<b>AMENDMENT OF SOLICITATION/MODIFICATION OF CONTRACT</b>			1. CONTRACT ID CODE		PAGE OF PAGES 1   6		
2. MODIFICATION NO.:  0001		3. EFFECTIVE DATE  JUN 03, 2005		4. REQUISITION/PURCHASE REQ. NO.  W81W3G-2035-7181		PROJECT NO. (If applicable)	
6. ISSUED BY Department of the Army Baltimore District, Corps of Engineers Contracting Division P.O. Box 1715 Baltimore MD 21203-1715		CODE CA31		7. ADMINISTERED BY: Contracting Division, Contracts Branch CENAB-CT-C 10 S. Howard ST. Room 7000 Baltimore, MD 21203-1715		CODE E1P0100	
8. NAME AND ADDRESS OF CONTRACTOR (No., street, county, State and ZIP Code)				(x)		9A. AMENDMENT OF SOLICITATION NO. W912DR-05-R-0051	
				X		9B. DATED (SEE ITEM 11) MAY 19, 2004	
						10A. MODIFICATION OF CONTRACT/ ORDER NO.	
						10B. DATED (SEE ITEM 13)	
CODE		FACILITY CODE

**ADAL BALLISTIC TESTING FACILITY  
ICE, ALTOONA, PENNSYLVANIA**

AMENDMENT NO. 0001 TO RFP W912DR-05-R-0051  
EFFECTIVE JUN 03, 2005

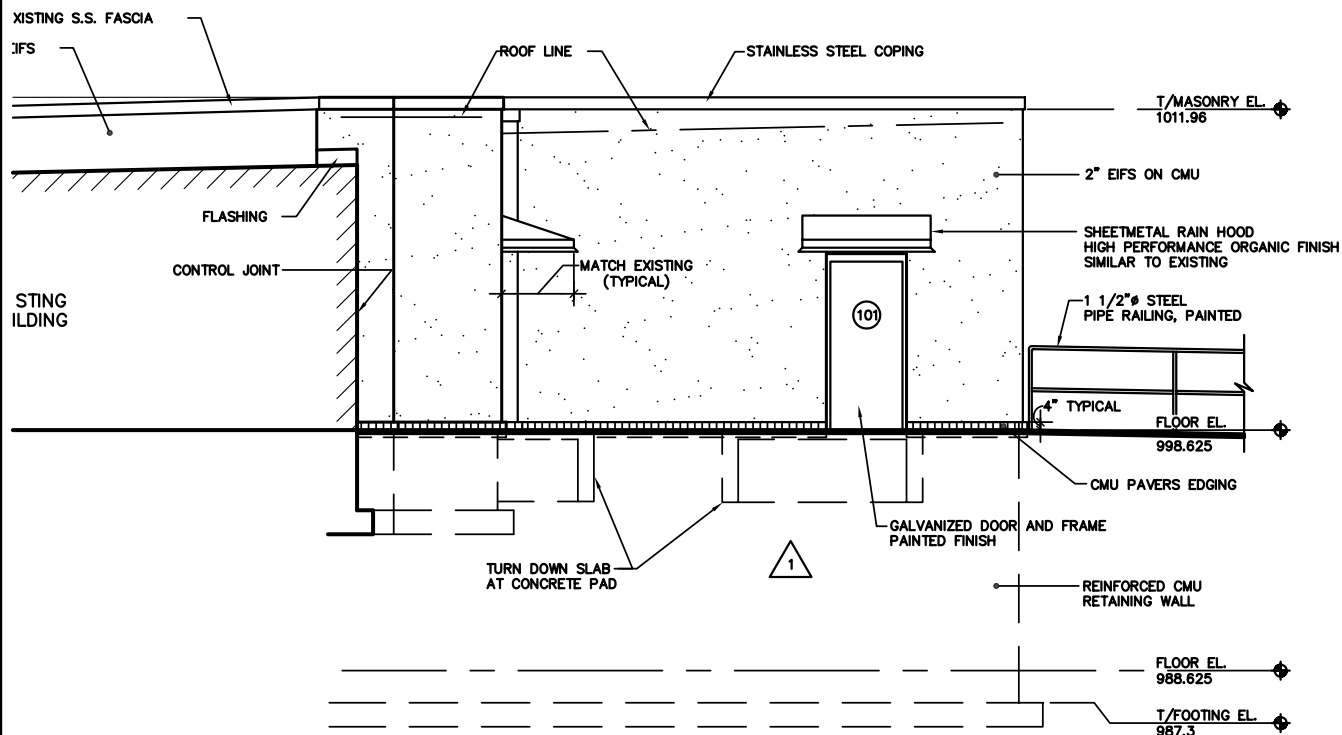
- b. First Floor Plan – Revise plan in accordance with the attached Sketch A-A-3, dated May 27, 2005.
  - c. First Floor Plan – Revise plan in accordance with the attached Sketch A-A-4, dated May 27, 2005.

**A-A-5**

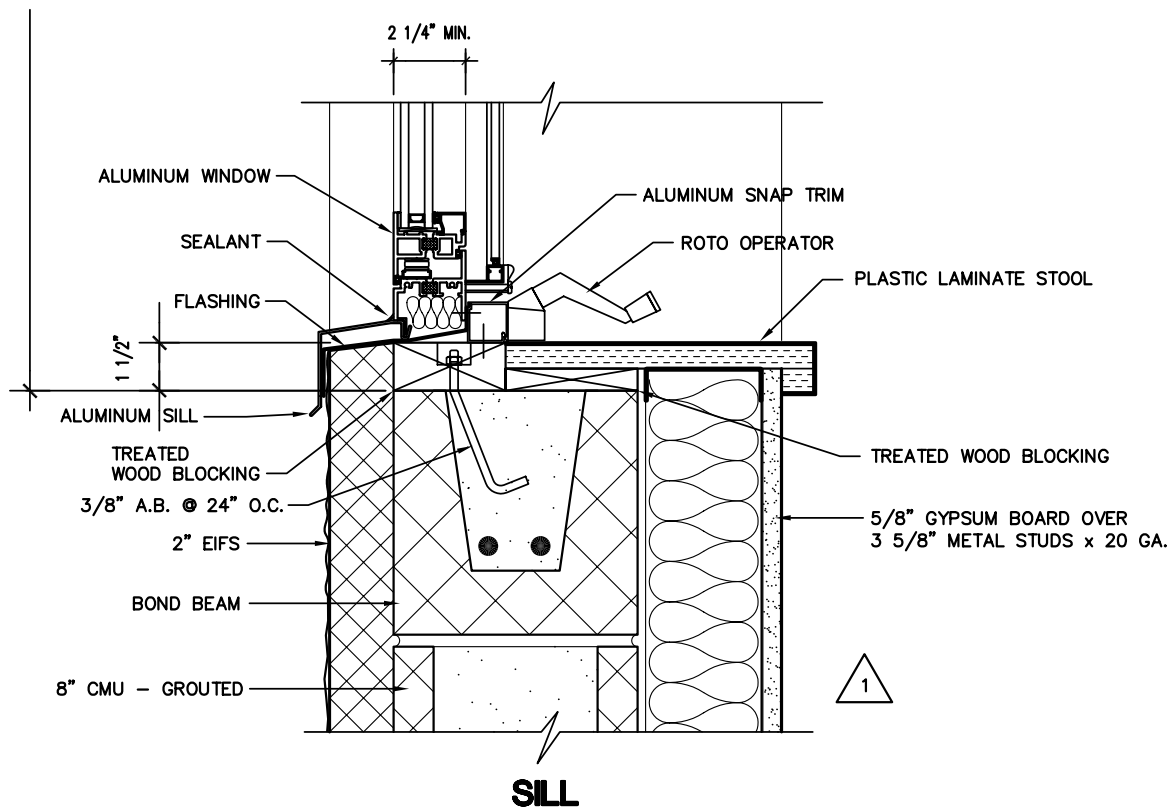
- a. East Elevation – Revise plan in accordance with the attached Sketch A-A-5, dated May 27, 2005.
  - b. East Elevation – Revised note at foundation to read “Reinforced CMU Retaining Wall”.

A-A-6

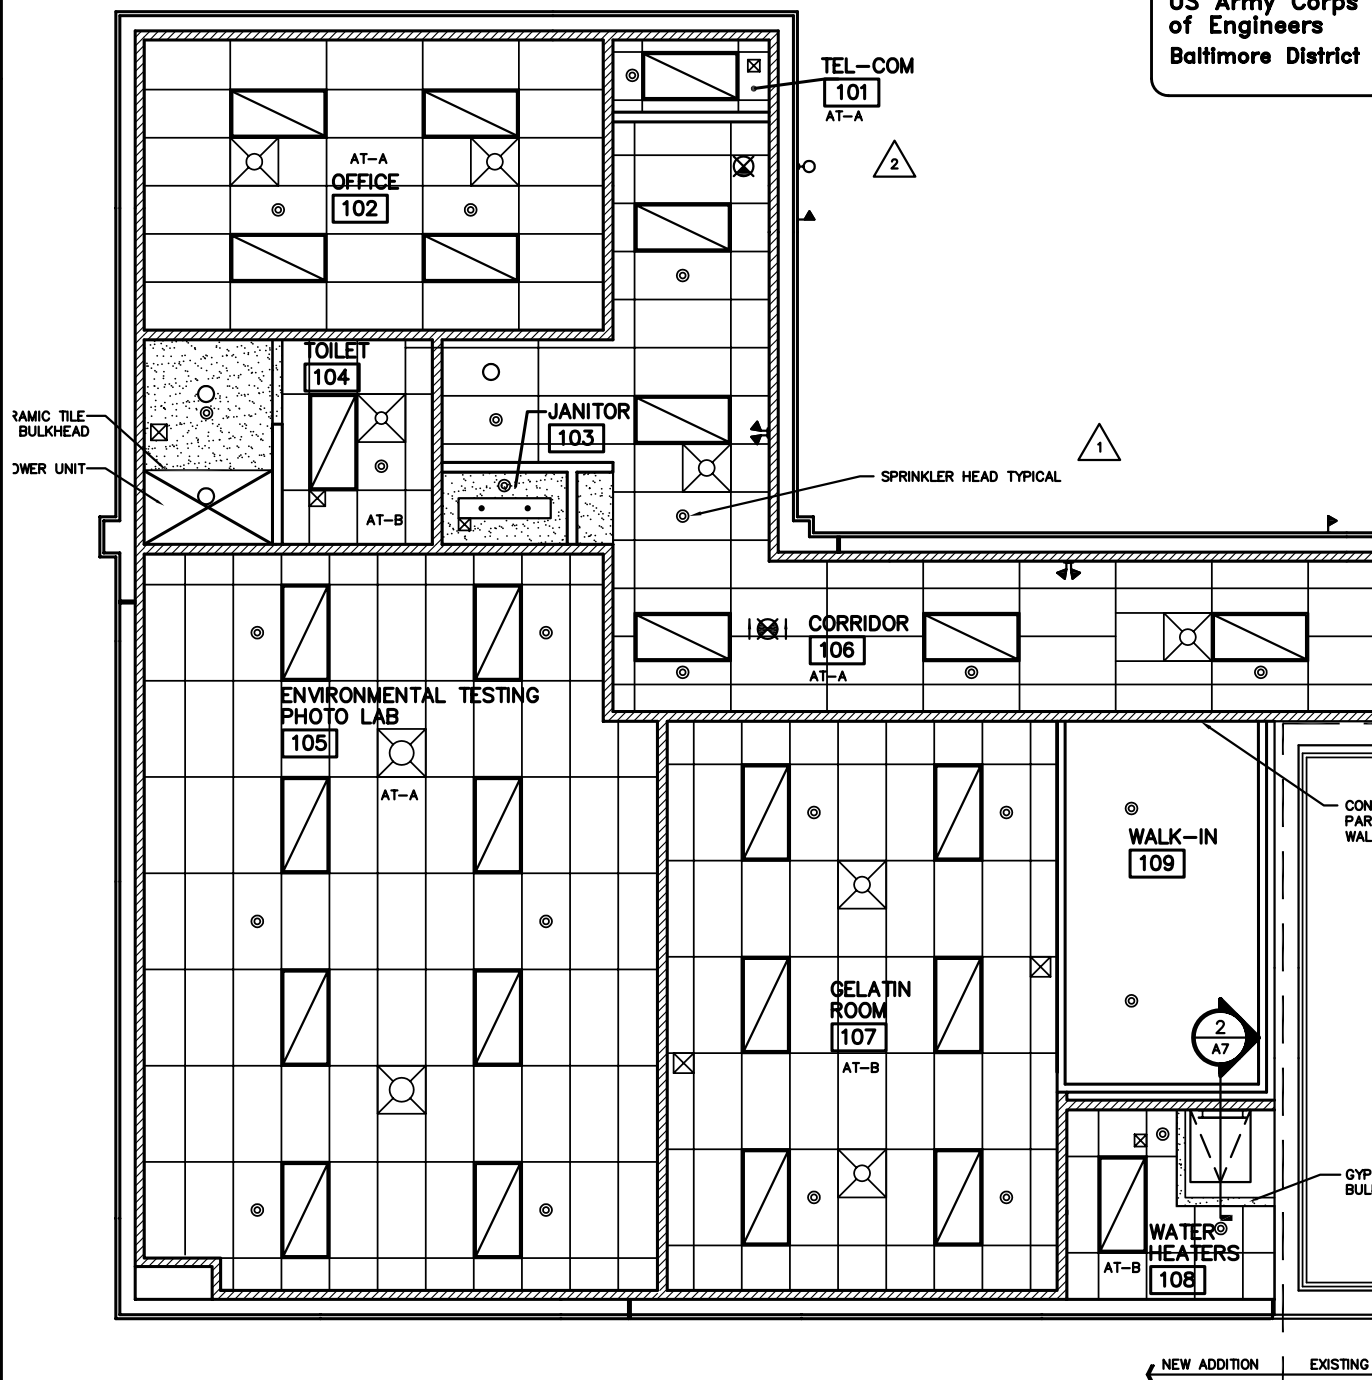
- c. Window Details – Revise plan in accordance with the attached Sketch A-A-6, dated May 27, 2005.

A-A-7

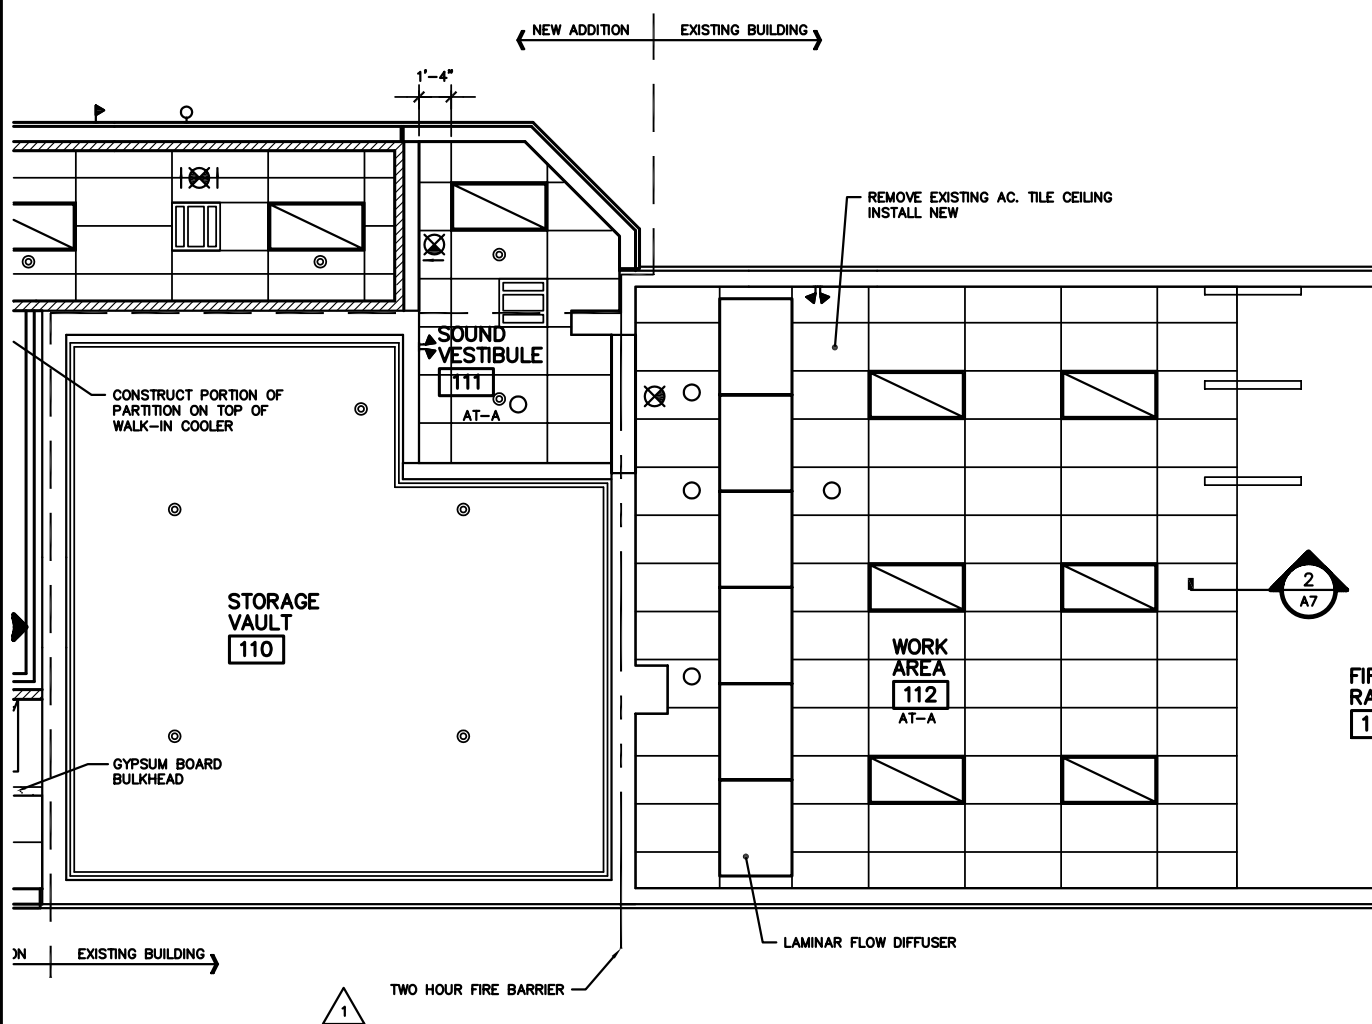
- 18) Plate 23, Reflected Ceiling Plan: Revise plan in accordance with the attached Sketches A-A-7 and A-A-8, dated May 27, 2005.
- 19) Plate 24, Wall Sections and Details: Delete this plate in its entirety as originally issued and substitute the attached revised like-numbered plate, dated May 27, 2005.

**A-A-9**

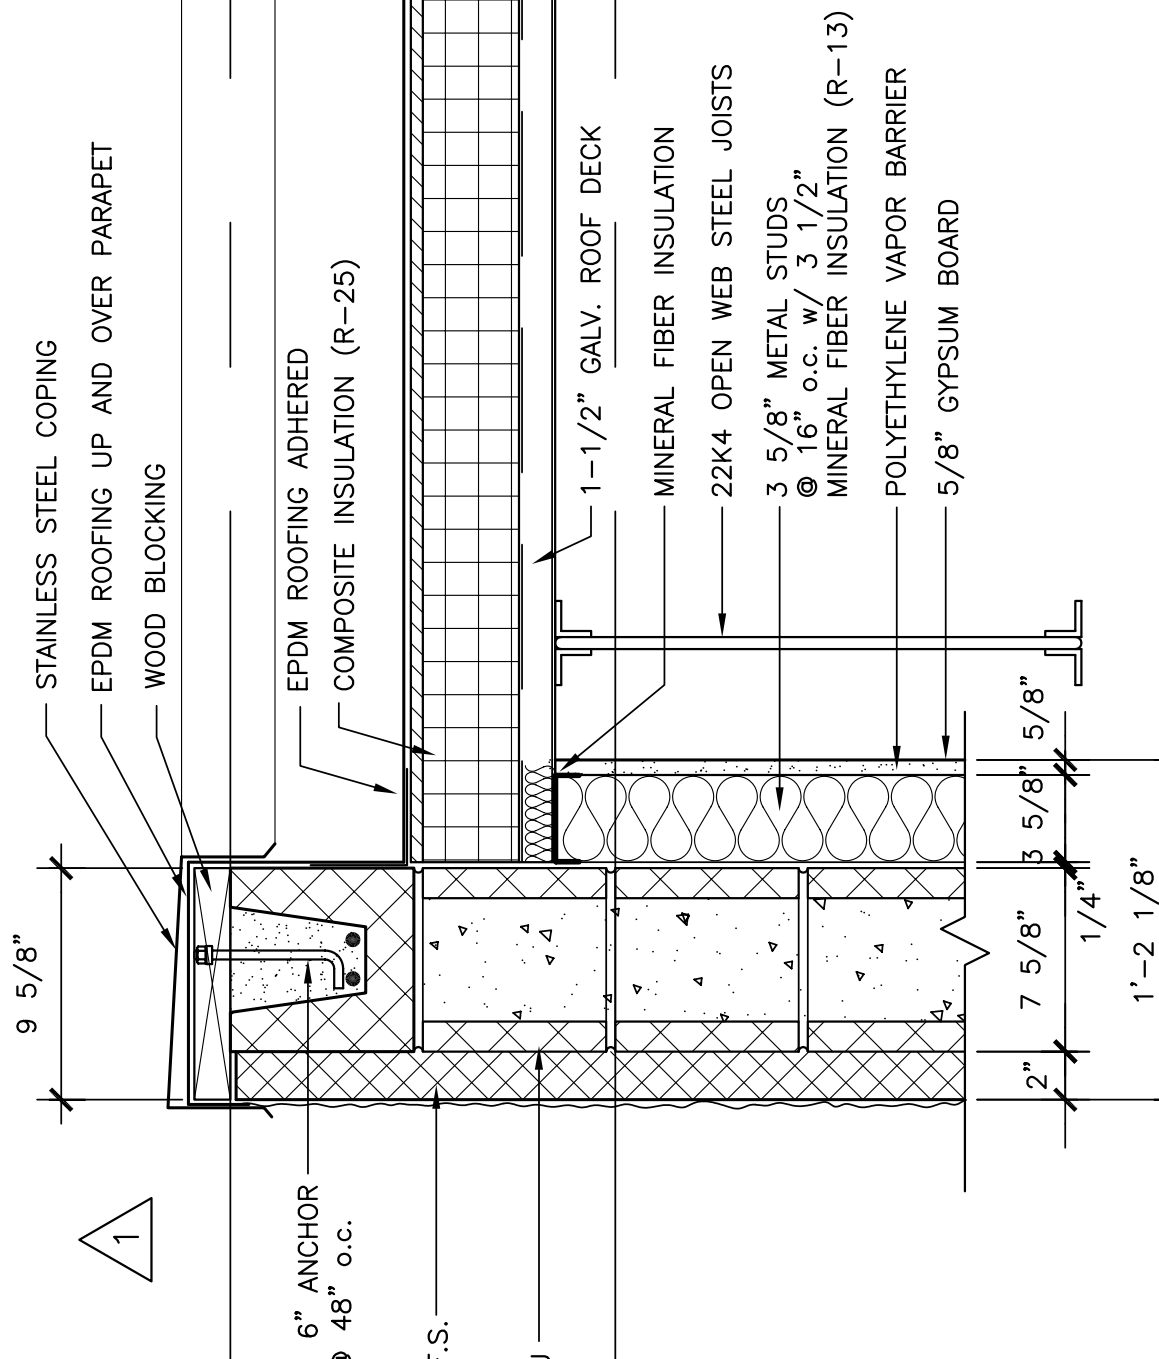
- b. Door Types – Revise in accordance with the attached Sketch A-A-11, dated May 27, 2005.
  - d. Details 1 and 2 – Revise details in accordance with the attached Sketches A-A-9 and A-A-10, dated May 27, 2005.
